**NSLPP MEETING HELD ON 07/09/2022****Attachments:**

ADDRESS/WARD: 28 Darley Street, Neutral Bay**APPLICATION No:** D115/22

PROPOSAL: Alterations and additions to a heritage-listed dwelling including demolition of the existing rear wall and construction of single-storey rear addition with a patio.

TITLE
PROPOSED PLANS
GROUND & ROOF

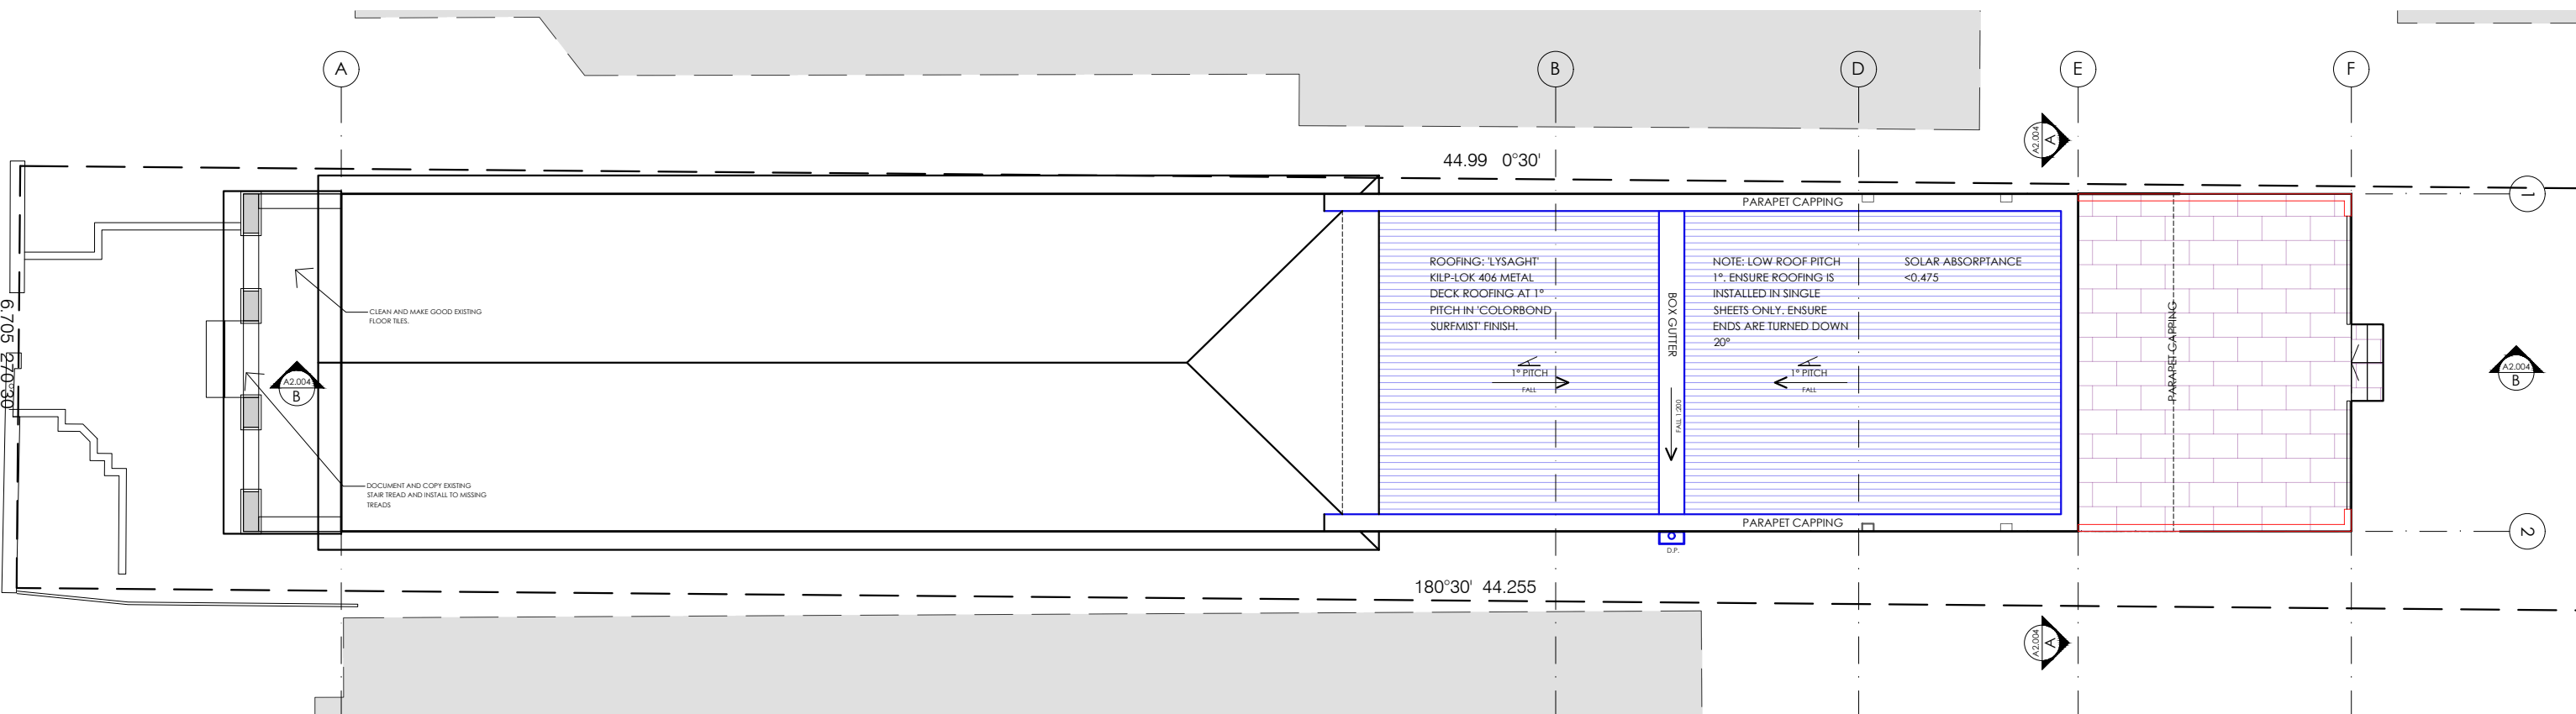
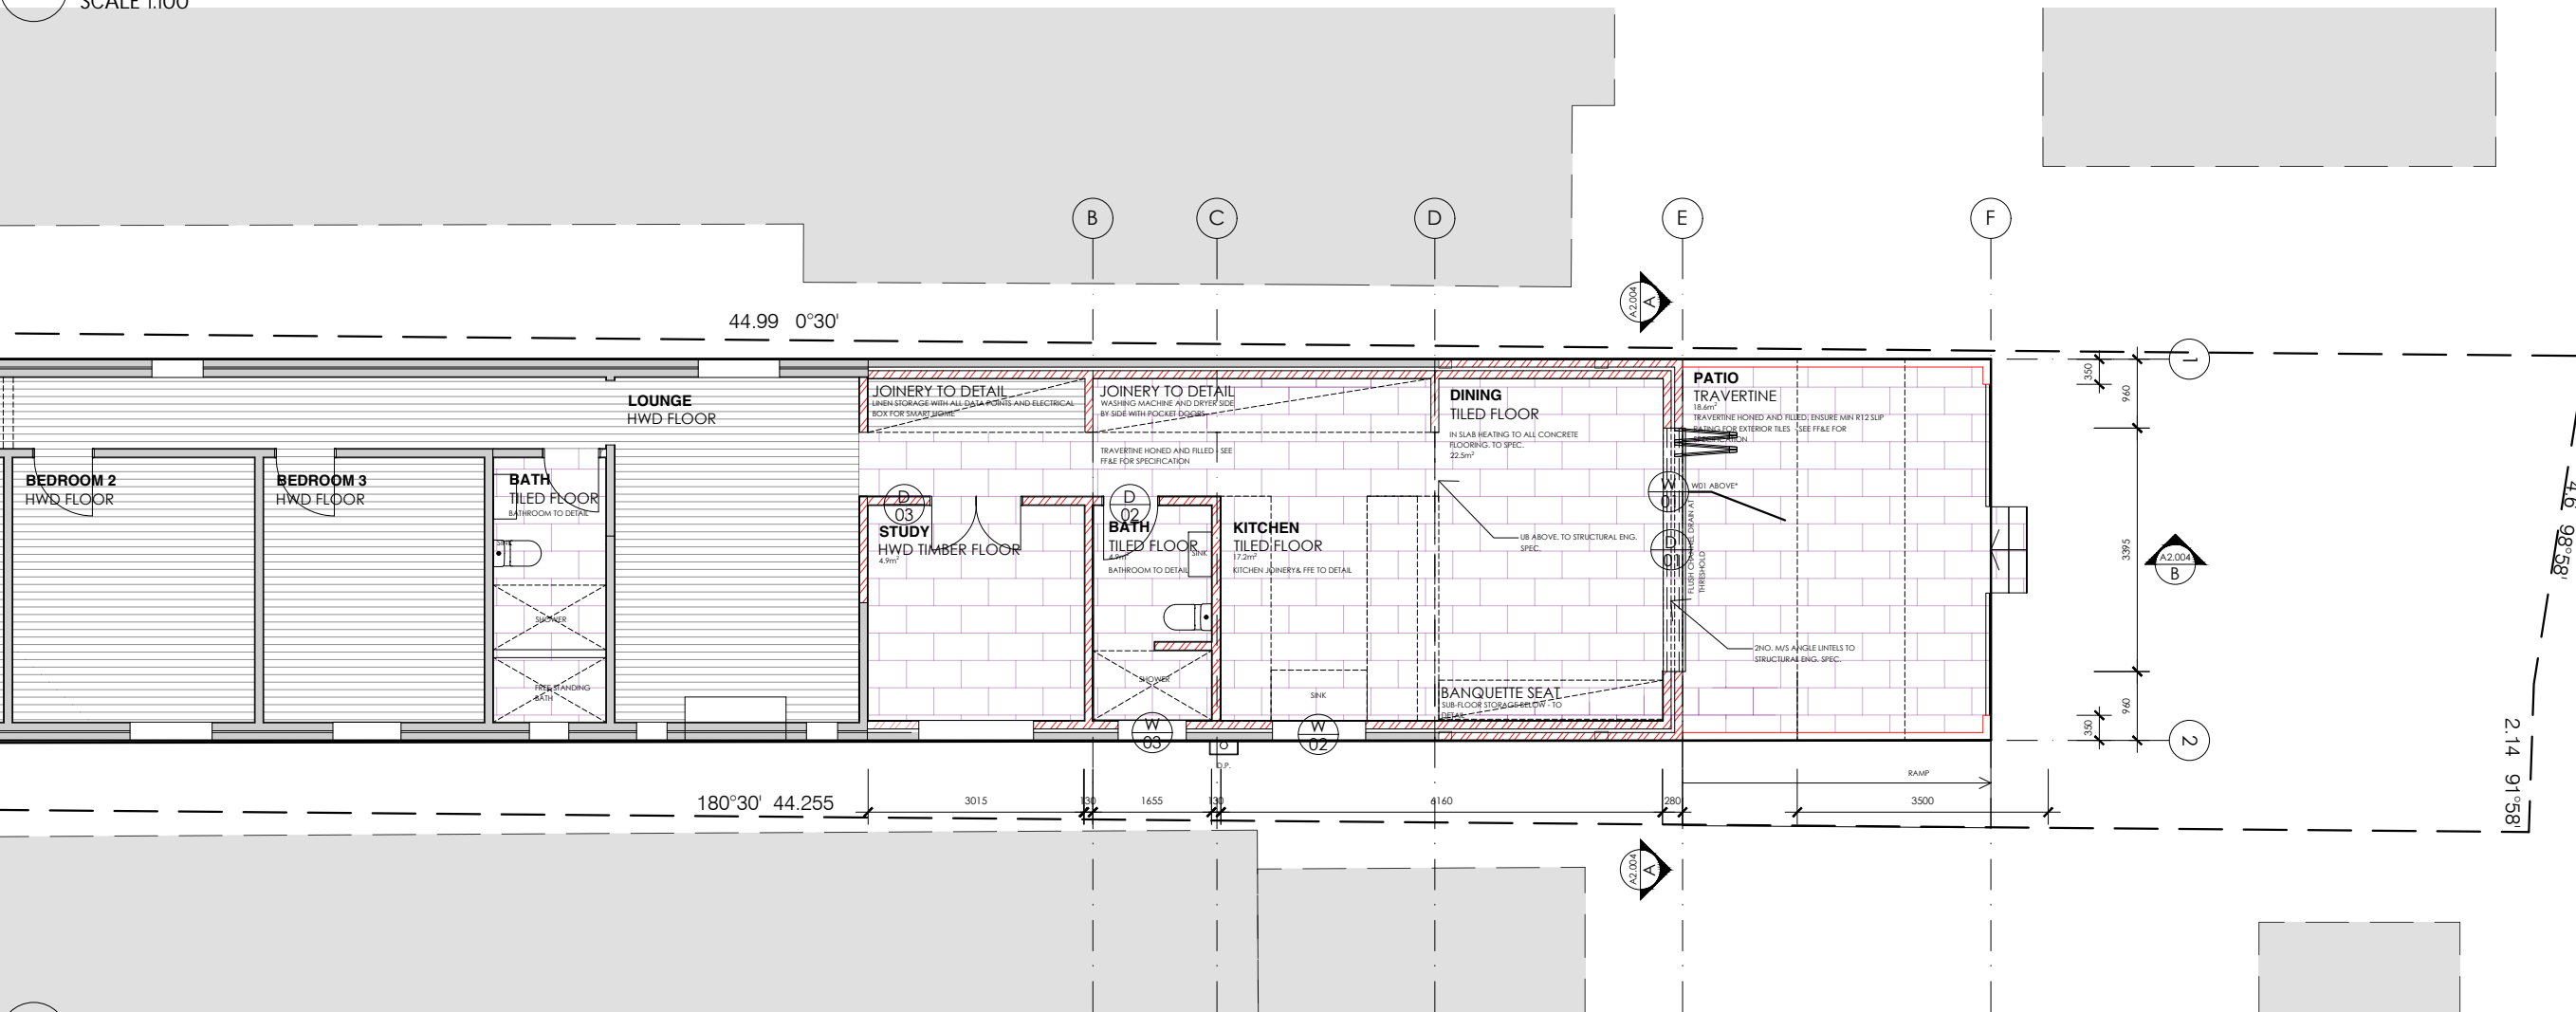
The proposed height of the rear addition complies with the LEP maximum building height control of 8.5m, being 4.302m in height. The length of the side elevation of the proposed addition will be further reduced by 1030mm to ensure that the DCP site coverage requirement of 50% is met. A condition has been recommended for plan amendment: **Condition No. AA1**. It is noted that the length of the proposal is similar to additions at Nos. 14, 18 and 20 Darley Street.

It is recommended that a condition be imposed requiring a further rear setback to ensure compliance with the DCP site coverage requirements. This will result in a reduction in the length of the extension of 1030mm. The height of the rear addition complies with the maximum building height control at clause 4.3 of the LEP. Conditions have been imposed for an amended landscape plan to be provided, which includes additional plantings of shrubs, trees and ground cover which will improve the natural aspect of the subject site. With respect to property values, this is not a consideration under assessment under the Environmental Planning and Assessment Act 1979.

There are no formal arrangements or positive covenants in relation to the creation of a maintenance easement on the adjoining property. Notwithstanding this, the dwellings have been maintained over their 110 year existence.
P1 Front setback	No change	The proposed works would not change the building setback from the front (Darley Street) Property boundary.
P5 Rear Setback – Rear	Yes	<p>Whilst the subject property is located between two detached dwelling houses which are similarly set on their lots with a zero setback on one side boundary. The proposed rear extension with a patio at the rear of the dwelling has a 12.596m setback from the rear (northern) property boundary that is a minor variation to the rear building setbacks of adjoining dwellings at 26 and 30 Darley Street. One of the neighbouring properties (no.26) has a studio within the rear setback and does overshadow the private open space of the subject site. It was constructed without development consent, but nevertheless a Building Certificate was issued by Council.</p> <p>Given the variations in housing typology in the vicinity, the proposal is generally considered to be acceptable having regard to the rear building setback. However, as the amended proposal is not compliant with the 50% site coverage requirement, a further amendment is recommended to reduce the length of the rear extension by 1030mm (see previous comments) which will further increase the rear setback from 12.596m to 13.626m. (See Condition No. AA1).</p>

TITLE
 LANDSCAPE PLAN

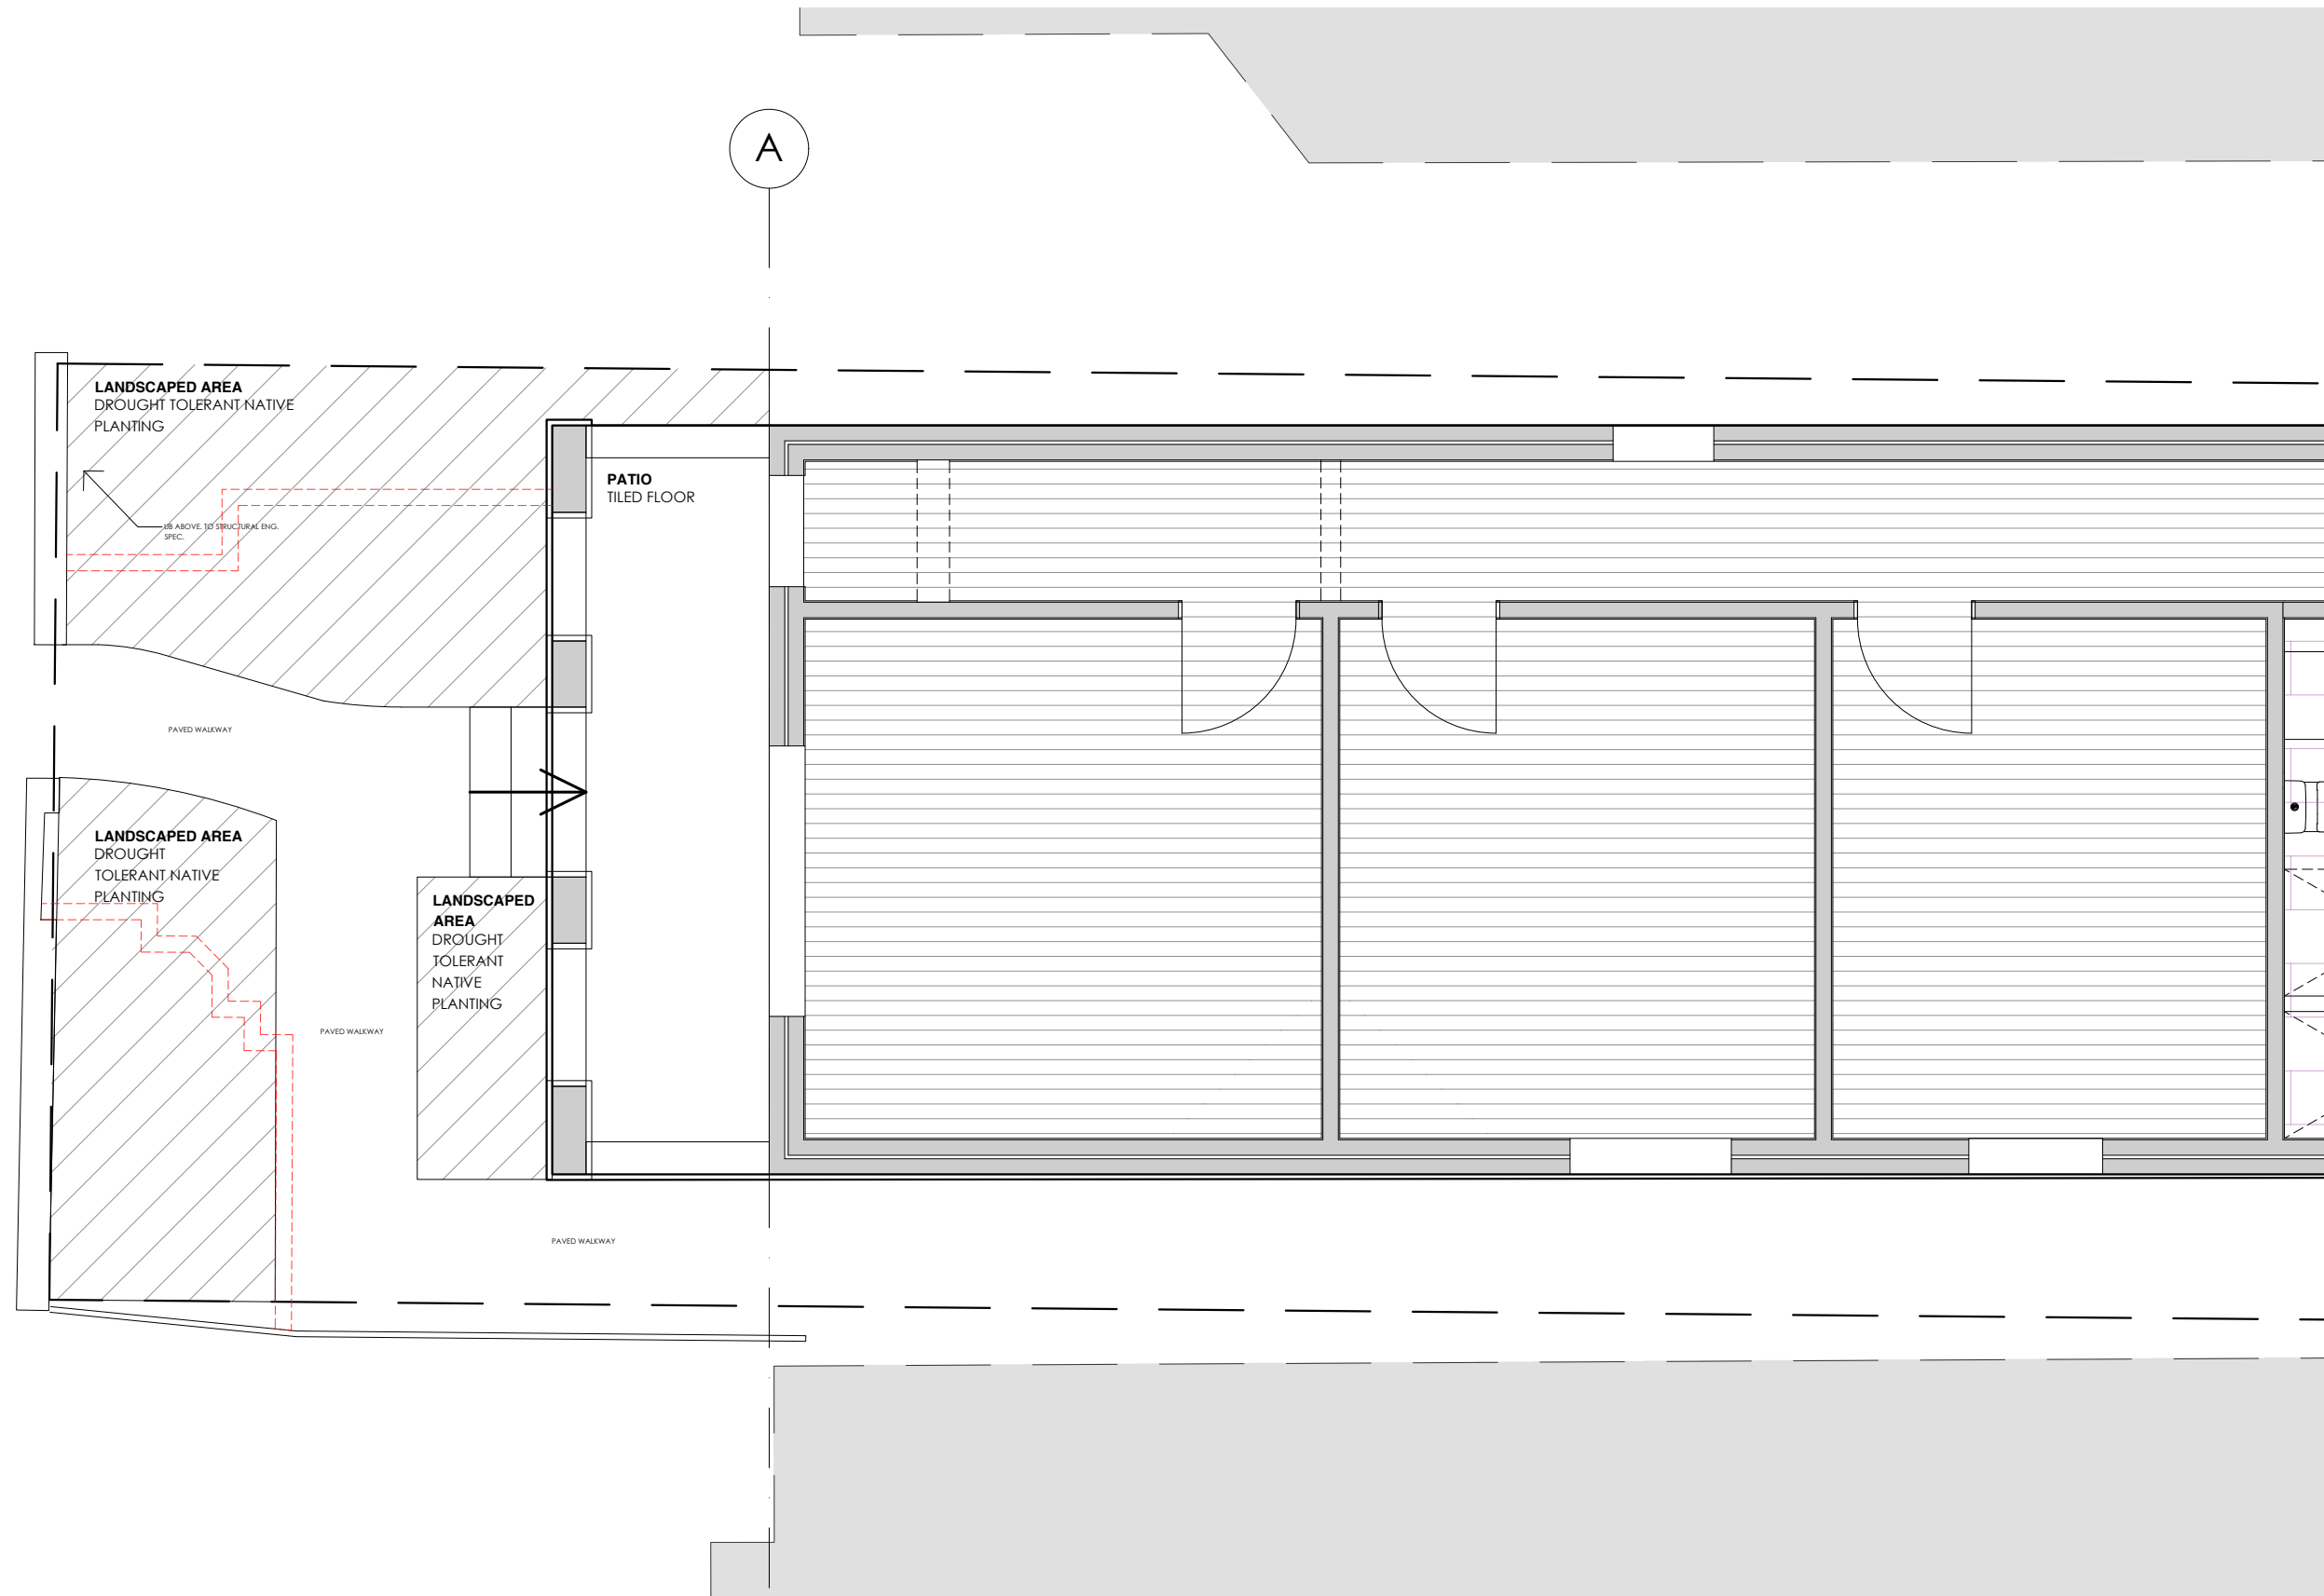
A condition is recommended requiring the submission of an amended landscape plan including species list and planting details to ensure a desirable landscaped outcome for the subject site and the locality (**Condition No. AA2**). In addition, appropriate conditions are also recommended requiring the protection of an existing street tree in front of the subject site, and for a street tree bond and species to be imposed, and for tree protection of existing trees on site. (See **Condition Nos. C14, C15, D1, D2**).

1.5.8 Landscaping	Yes (via condition)	The proposal will reduce the soft landscaped area by 6m ² . A condition is recommended requiring an amended landscape plan to be provided prior to issue of construction certificate. This is to include the planting of trees, shrubs and groundcovers within the front setback and the rear garden. The amended landscape plan will ensure that there is suitable landscaping within the front and rear areas and ensure adequate landscape screening is provided to address privacy impacts, and to ensure that the character of the locality is preserved. (Condition No. AA2) . Council's Landscape Officer has recommended a street tree bond condition. (Condition No. C14) .

AA2 An amended landscape plan must be prepared and submitted for approval prior to the issue of a construction certificate. The landscape plan is to show the landscaping treatment for the front garden and rear garden including the species names, number and pot size of new planting.

The amended landscape plan must include the following:

- (a) Details on planting within the front setback including Australian East Coast native plant palette of ornamental grasses, perennials and shrubs as outlined in Letter from James Bowman, Archicode Architect, dated 10 August 2022, subject: 'Strictly compliant landscaped area and additional tree plantings'.

- (b) The provision of a winding path in traditional paving within front setback.
- (c) A suitable selection and number of shrubs and trees within both the front and rear setbacks in order to provide suitable landscaping embellishment and mitigate privacy impacts with adjoining neighbours

- (d) Details on protection of existing trees to be retained is to be provided
- (e) Details on protection of existing street trees is to be provided
- (f) Details on all new planting including name of the species, numbers and pot sizes, and planting details, establishment and maintenance is to be provided.
